# STATE HIGHWAY 105 / JACKSON CREEK PARKWAY - PHASE 2

## CONSTRUCTION PLANS

FEBRUARY 2023

JACKSON CREEK PARKWAY  
 TRAFFIC SIGNAL PLAN  
 STATE HIGHWAY 105

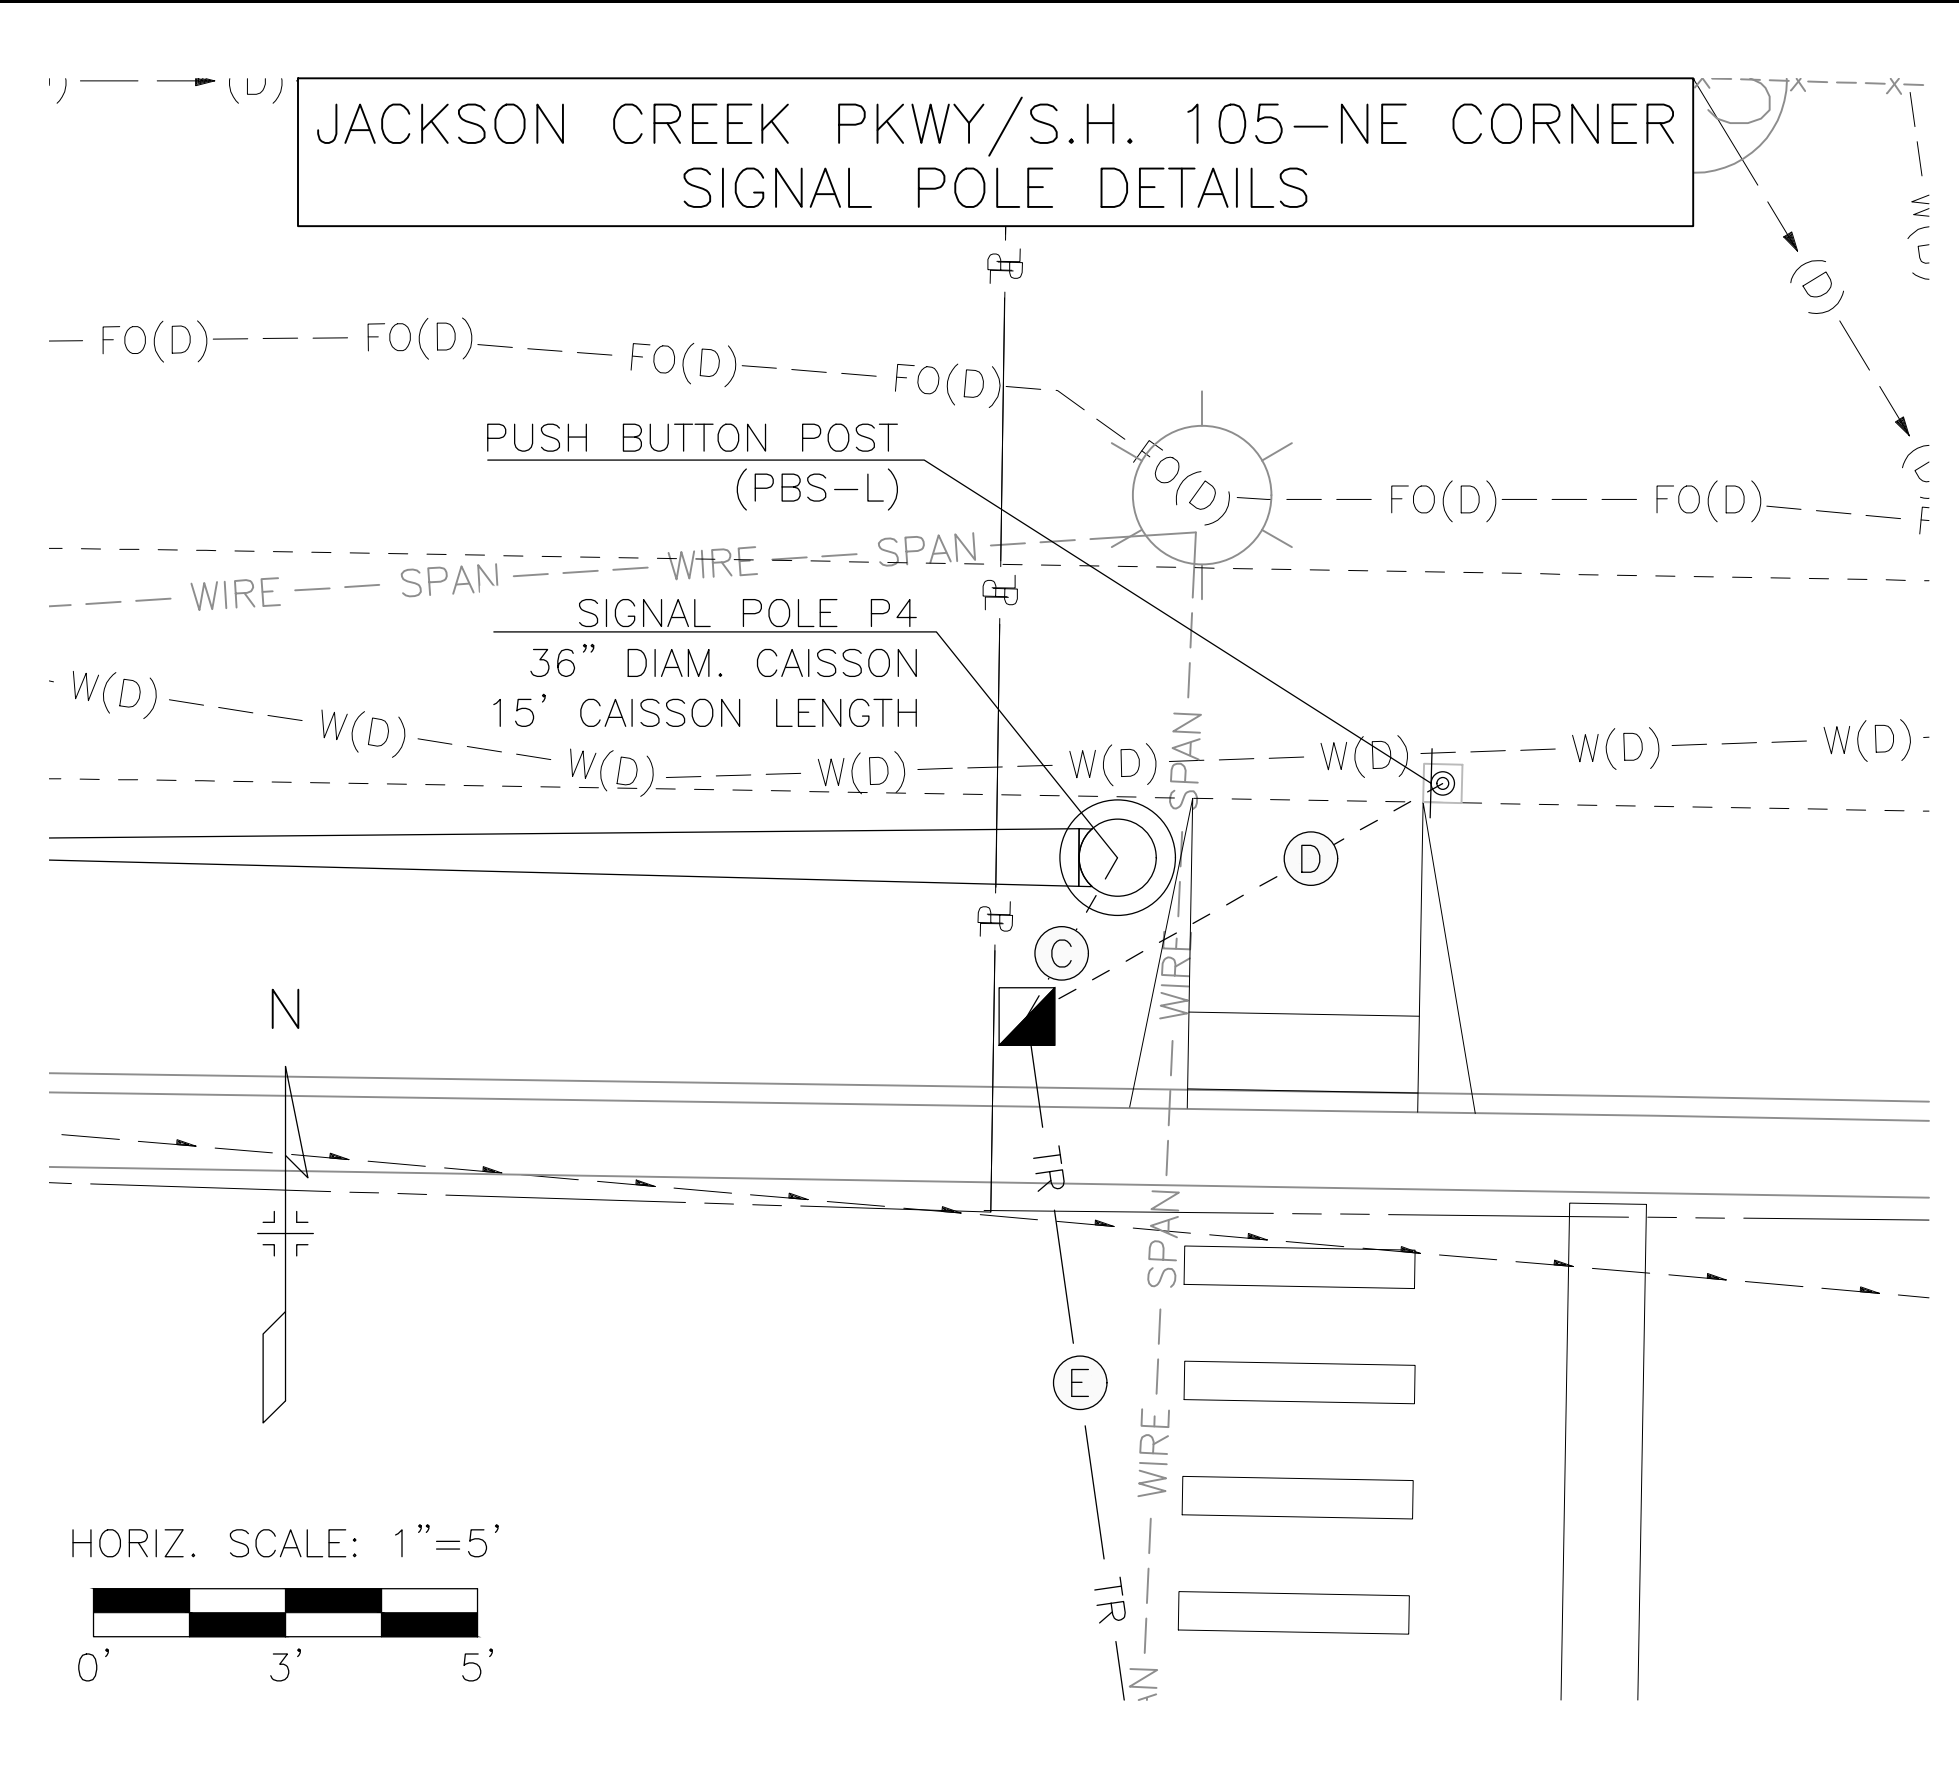
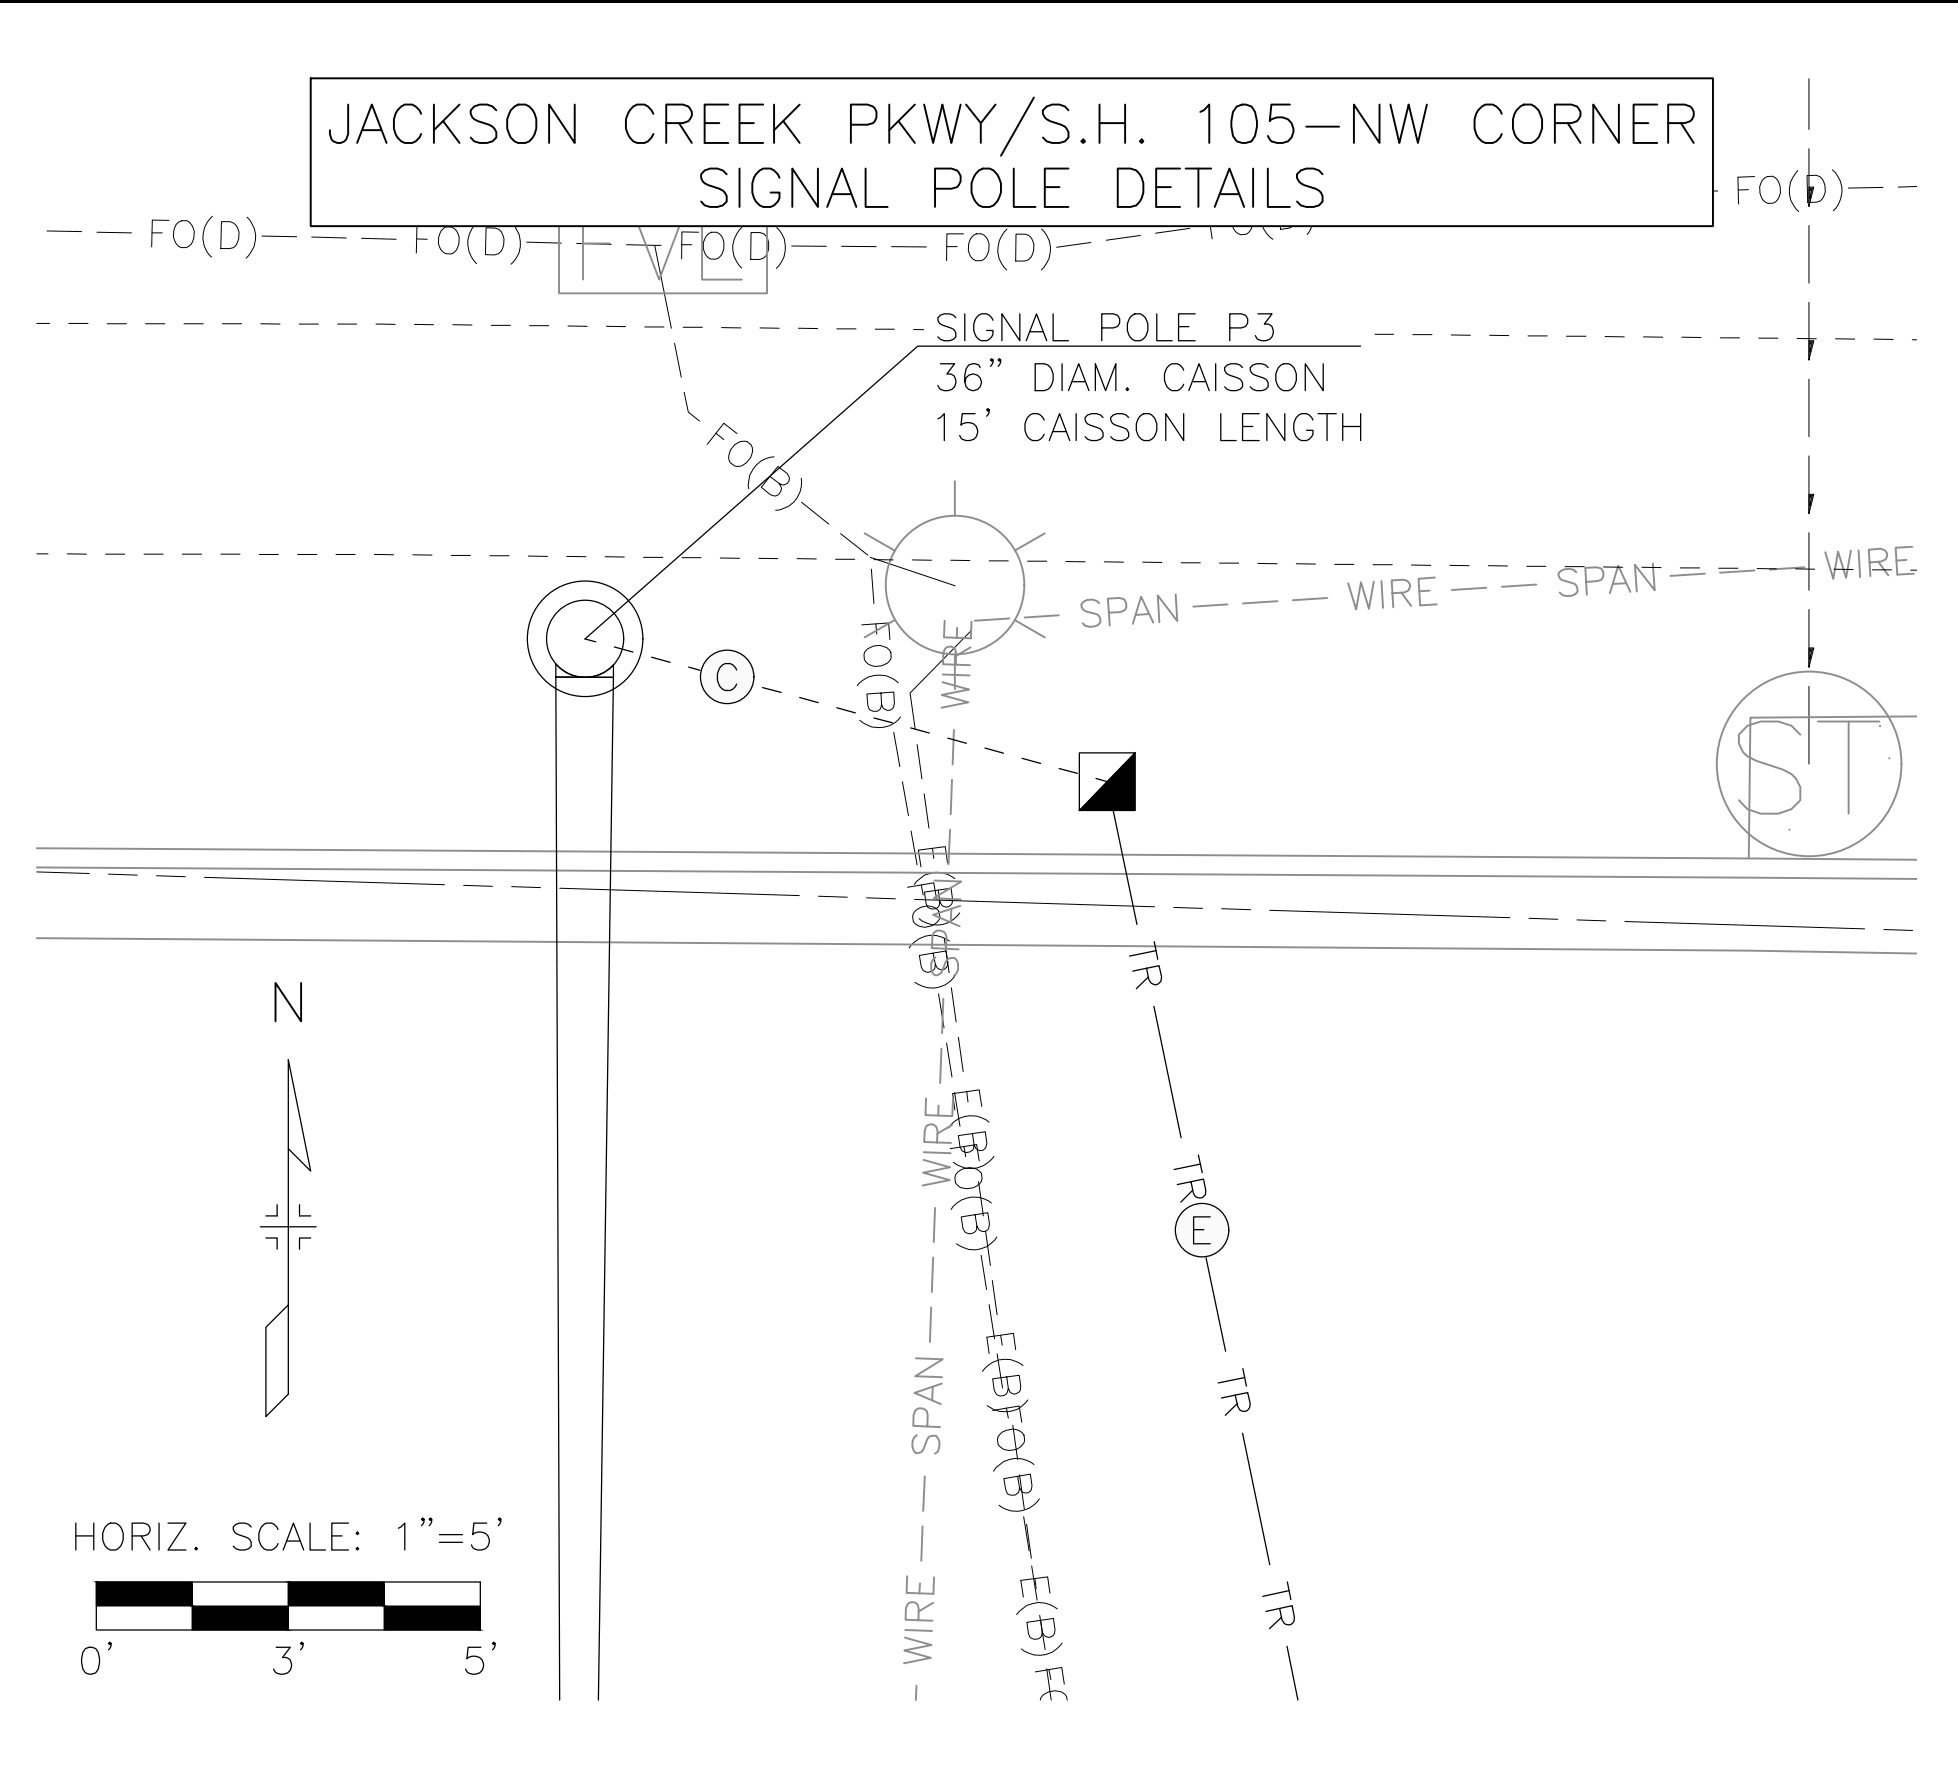
Suggest the curb ramp design provides provide way more details. elevations, slopes, placement of ramp along the face of the islands. I don't think these are easily buildable in the field.
